Willow Island Park Enhancements Community Oversight Committee Progress Meeting

June 8, 2023

- An electronic copy of this package has been sent by the consultants and will be shared with the full committee and DOS. A copy is also attached to these notes.

60% DESIGN DEVELOPMENT SET

PHASING PLAN

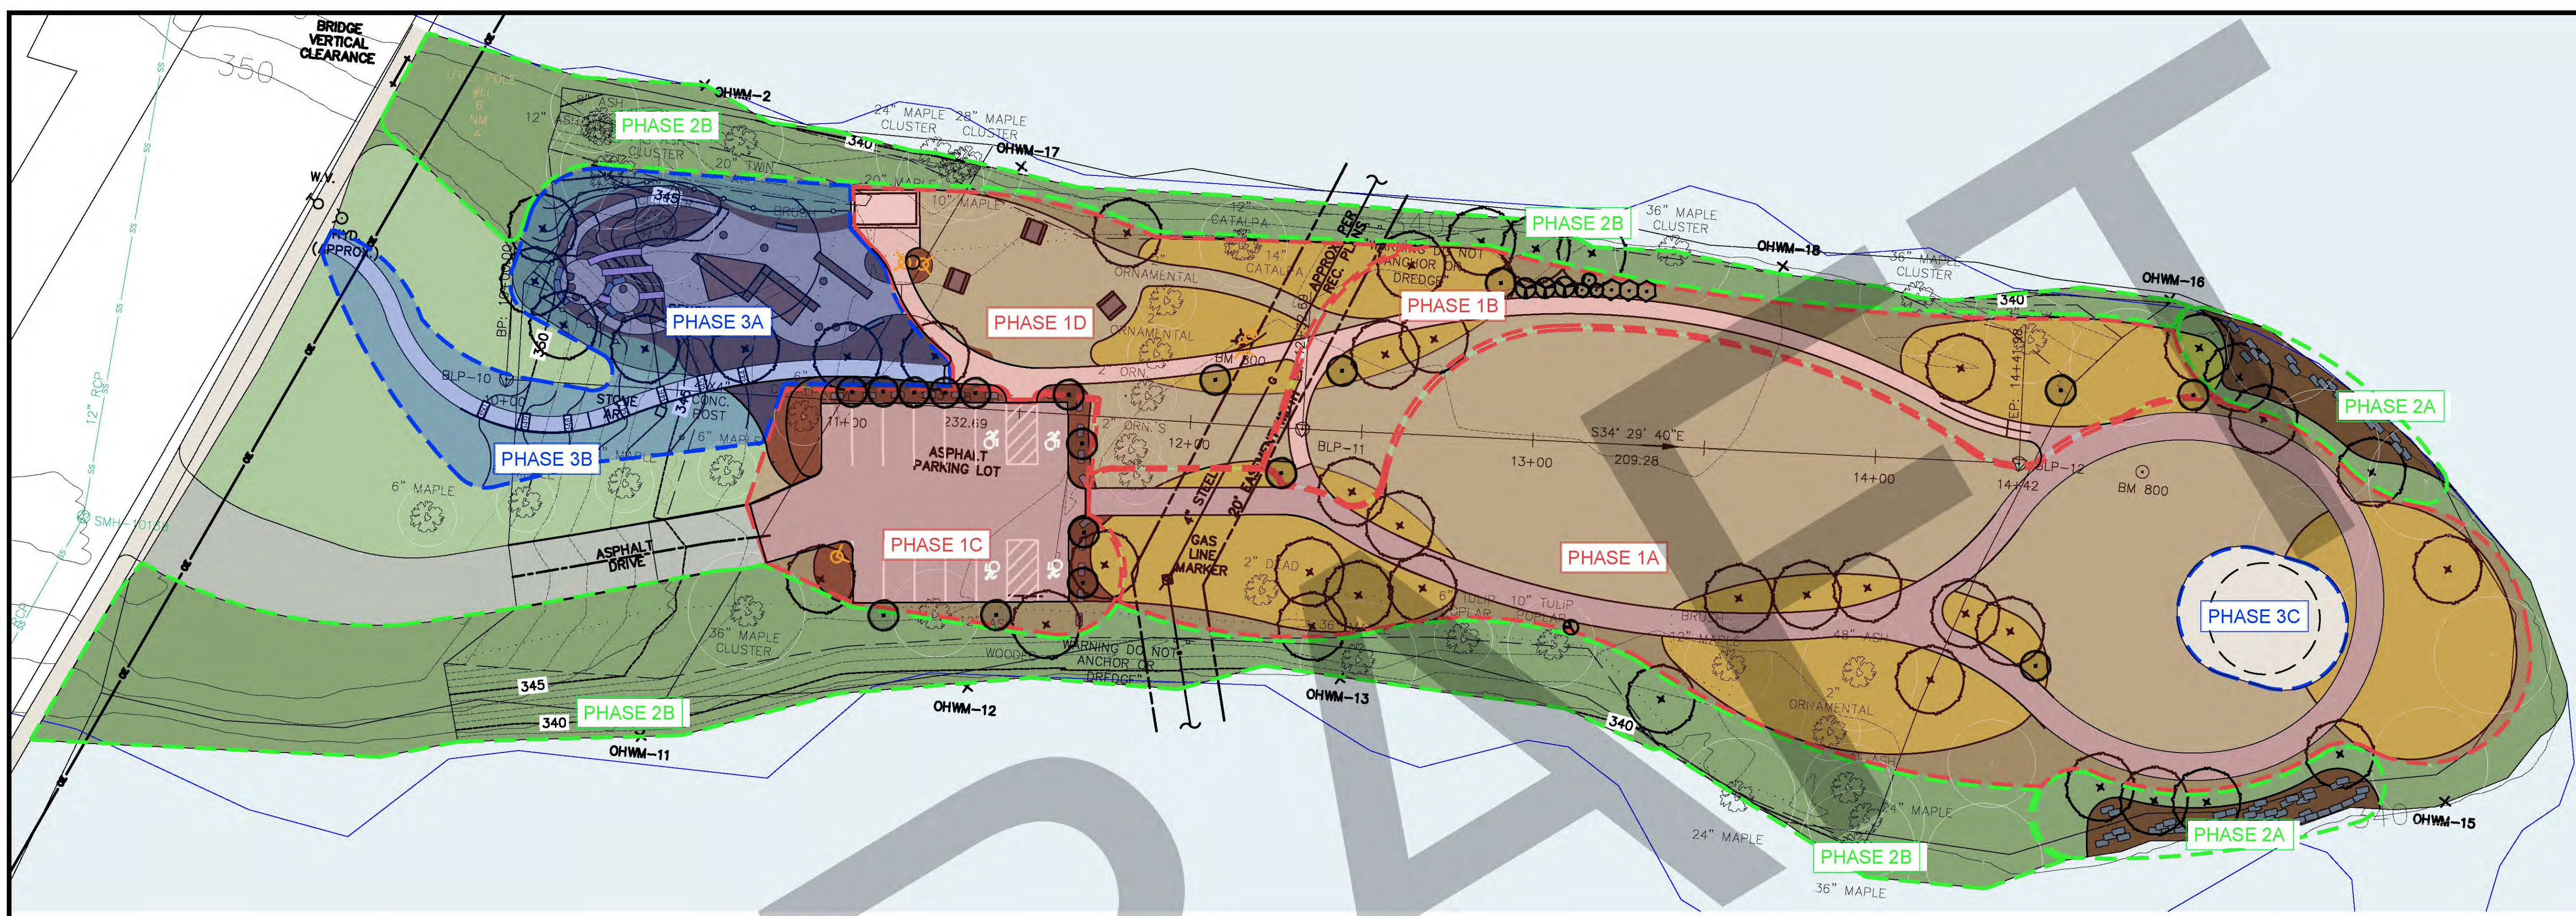
- Phasing Plan - Most Recent Update (6/7/23)
 - The updated phasing plan has been sent by the consultants and is attached to these notes.
 - Phase 1
 - Parking
 - Trail Paving - asphalt trail
 - The above items will be bid out and this piece is being worked on now.
 - Phase 2
 - Invasive species management
 - Streambank stabilization
 - Phase 3
 - Playground
 - Stage
 - The stage should not be affected by the streambank stabilization process and is essentially an independent project which will require separate funding.
 - All phases have been broken into categories that can be developed independently.
 - The numbers that come in from the bidding process will help determine how much of Phase 1 can be completed under the current grant.

- Noted: the bidding will include an 8-foot wide asphalt trail; if the costs are prohibitive, a 10-foot wide trail could be installed in-house.
- Review of 60% Construction Drawing Package

GRADING PLAN

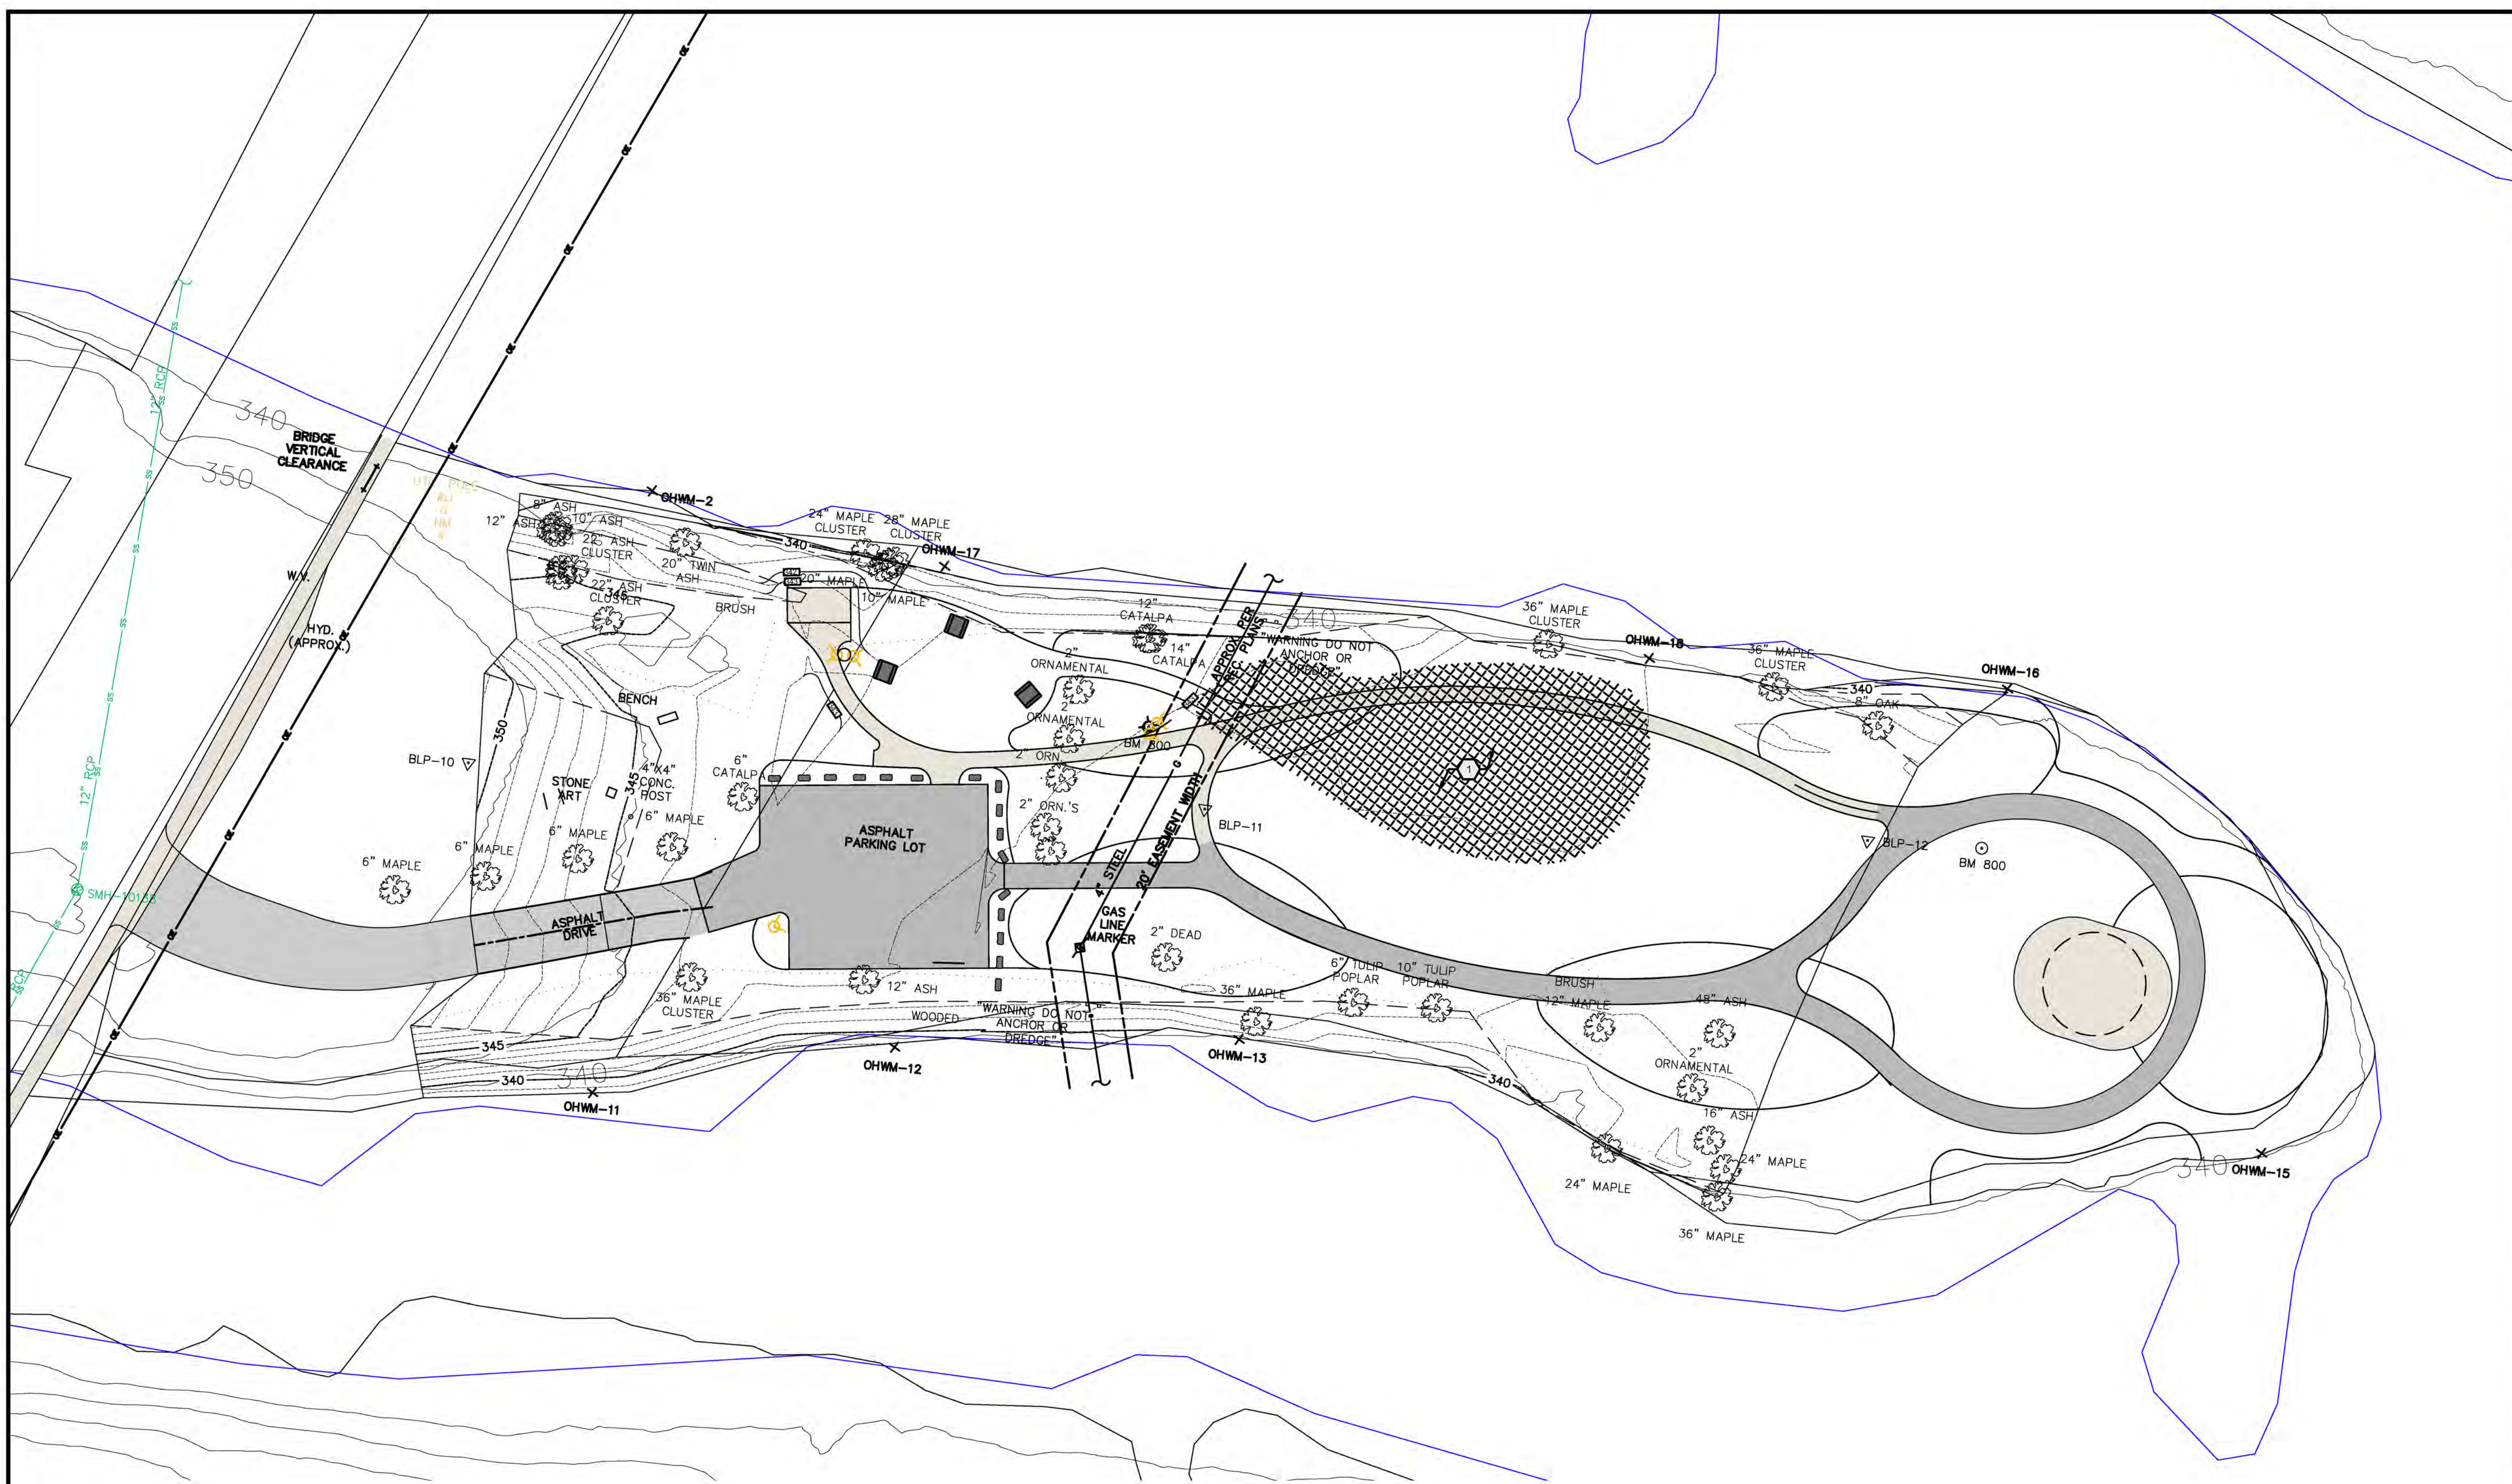
- It was noted that the Demolition Plan also indicates what items will be protected and maintained.
 - Grading & Drainage Plan
 - It was noted that some areas on the island that are currently slightly elevated can be leveled down to help provide any needed fill for the stage area.

LAYOUT & MATERIALS PLAN

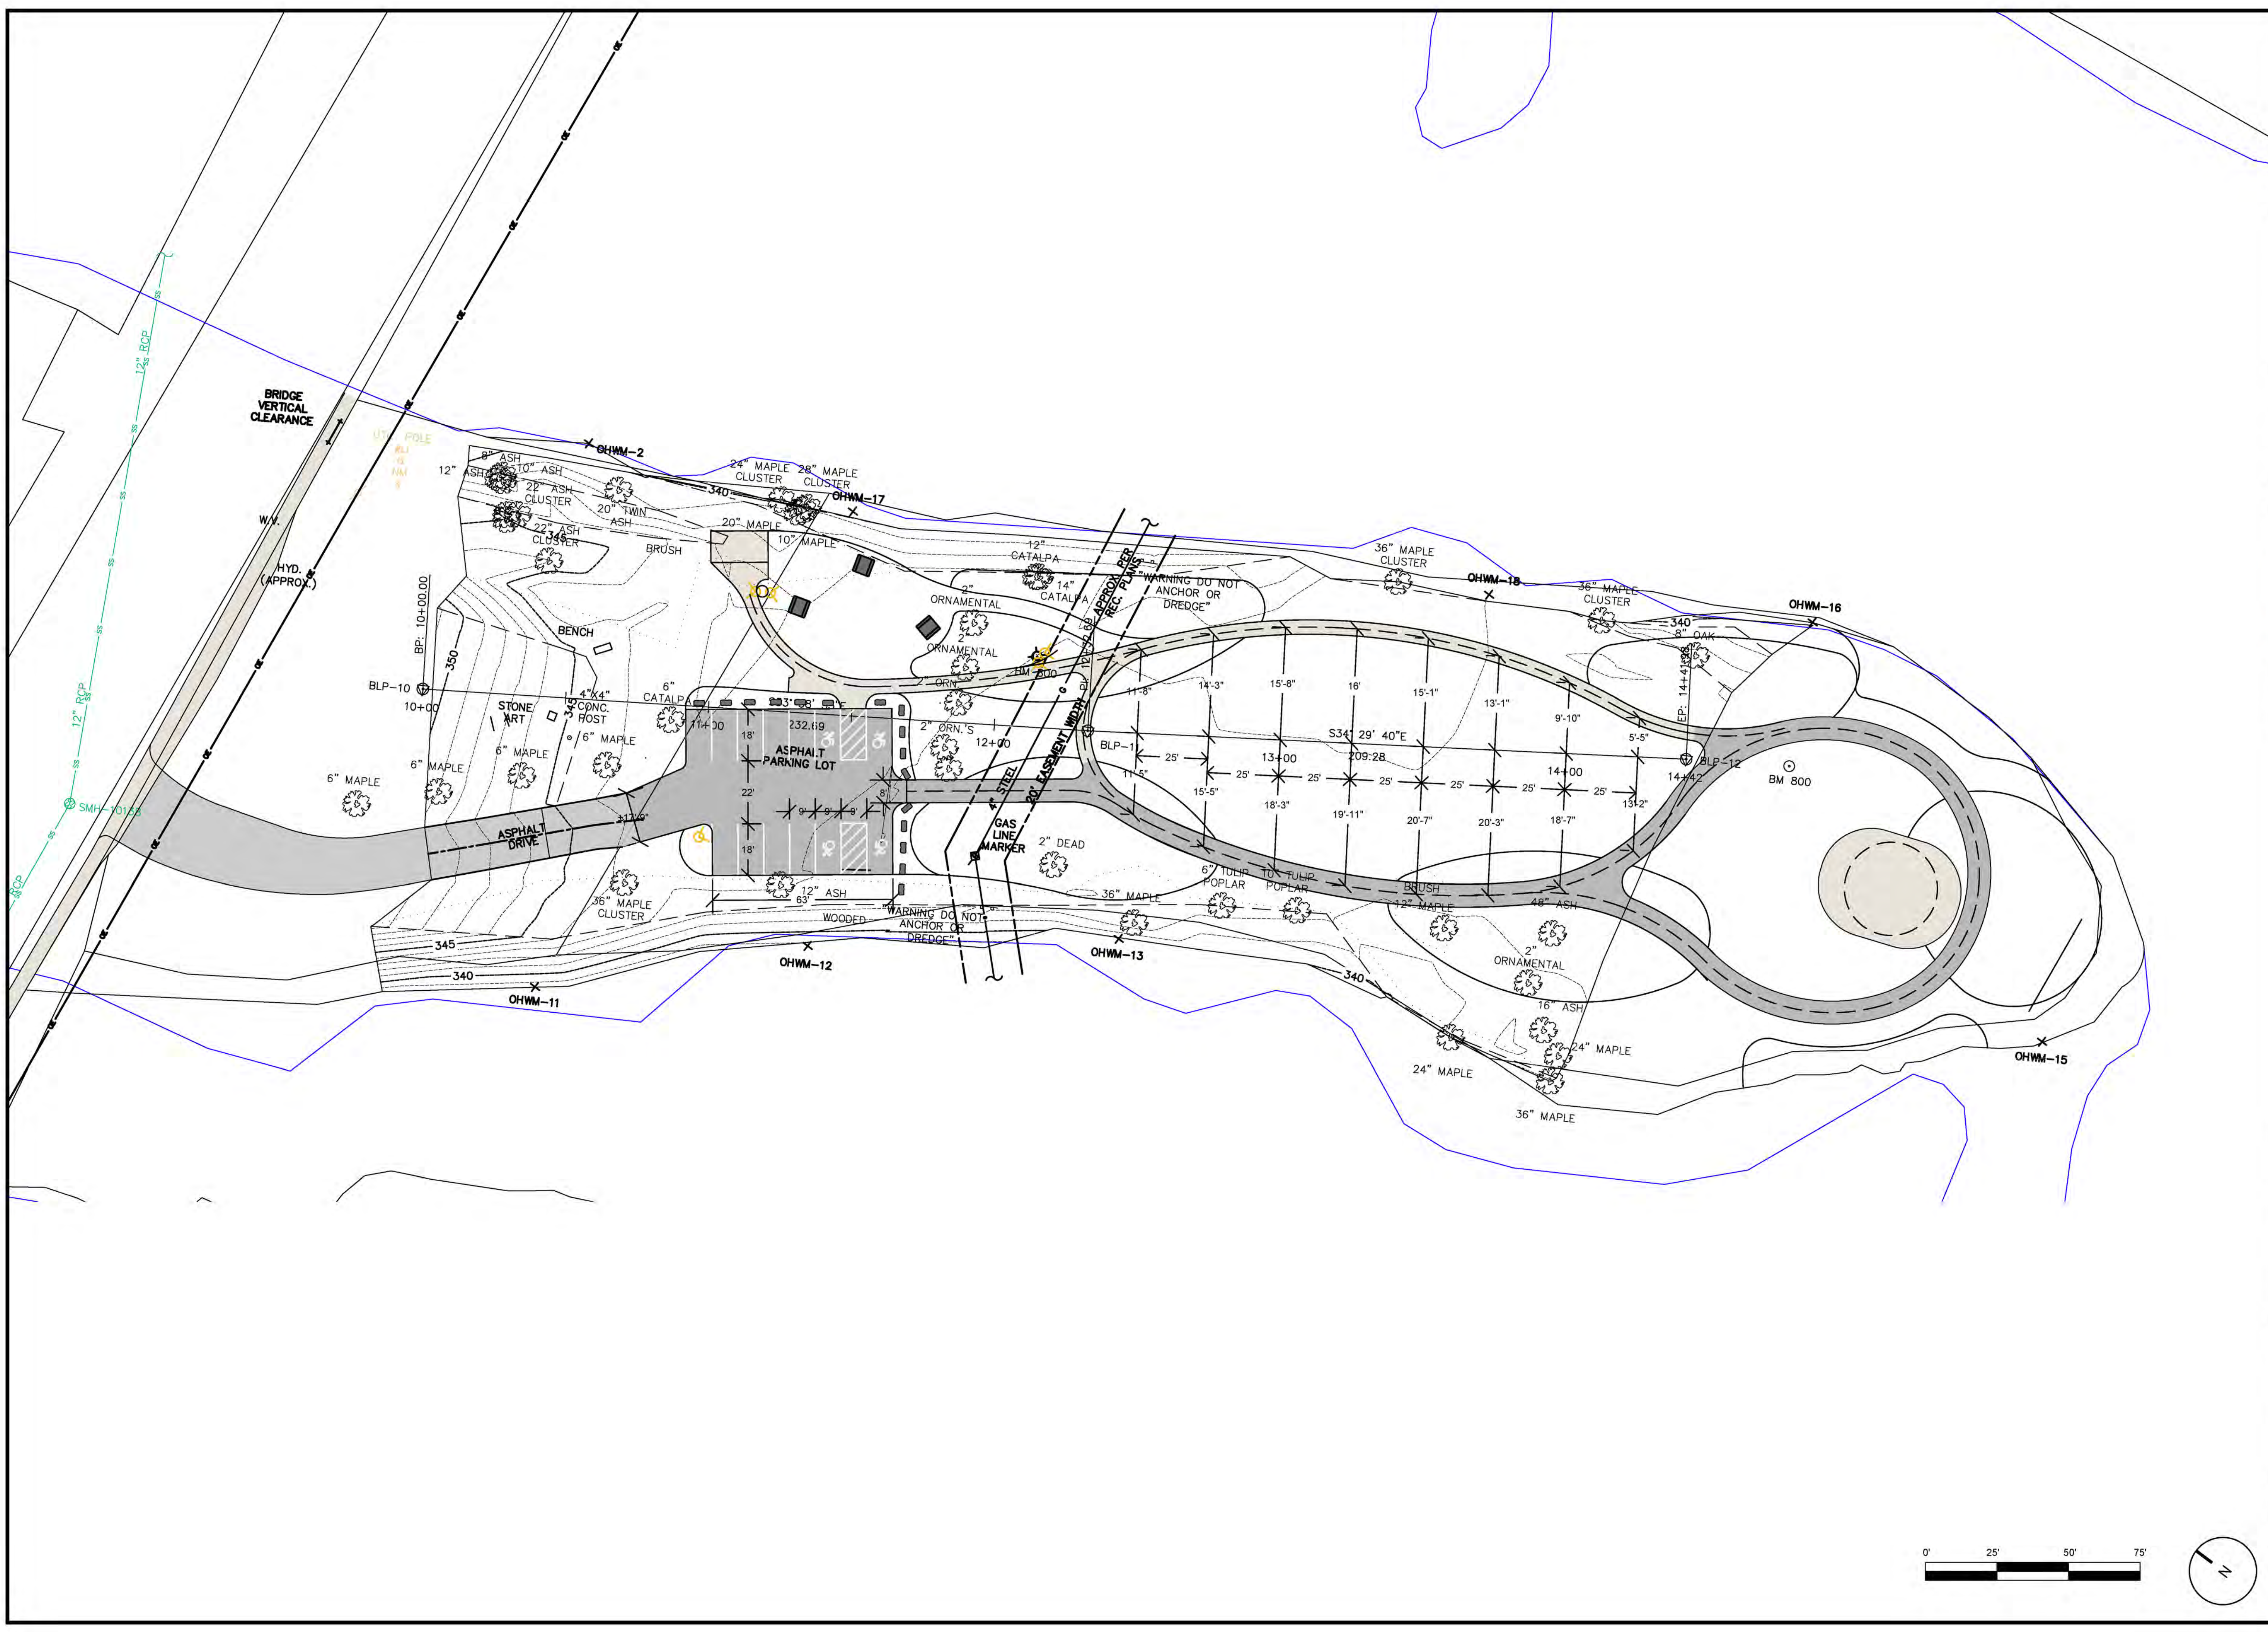
- Layout
 - This sheet shows all the anticipated dimensions of the components of the project, to help ensure all pieces are located appropriately.
 - It was noted that flagging & striping can be done in-house, and the consultants will need to connect directly with the person responsible for the layout.
